**Technical Service
Bulletin**

Date: 2010-08-12 **SAP DIR #: 20012608**

Subject: TSB – CP50 & CP50 Plus V01.20.01 SOFTWARE RELEASE

**Product(s)
Referenced:** CP50 and CP50 Plus Electrocardiographs

➤ Workflow improvement: Auto ECG Test Assignment

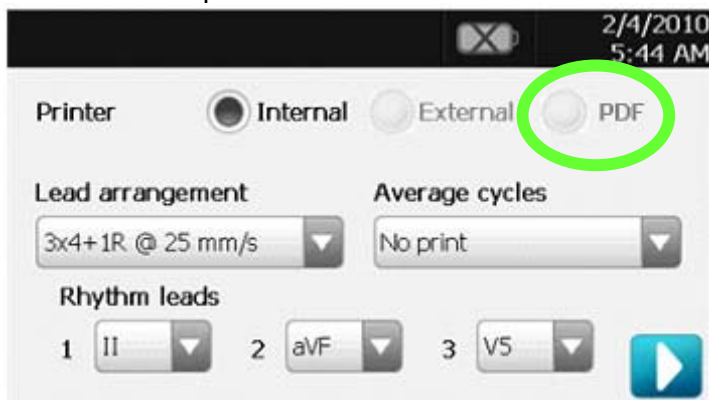
During an Auto ECG procedure, the patient information is requested.

User can choose the following actions:

- Enter the patient information manually
- Select a patient from a search
- Select a patient from the worklist
- Skip this step
- No change to the patient information of this test is permitted beyond this step. The improved workflow permits a test to be assigned if no patient information has been provided during the Auto ECG procedure.
- An “Assign” button will be visible in the Post ECG screen when the “Test Assignment” option is enabled in the ECG Configuration. This button will be enabled only if no patient information has been provided. Users can select patient from the local worklist. Once the test has been assigned to a patient in the Post ECG screen, the “Assign” button will be disabled.
- The above applies to STAT ECG procedure.
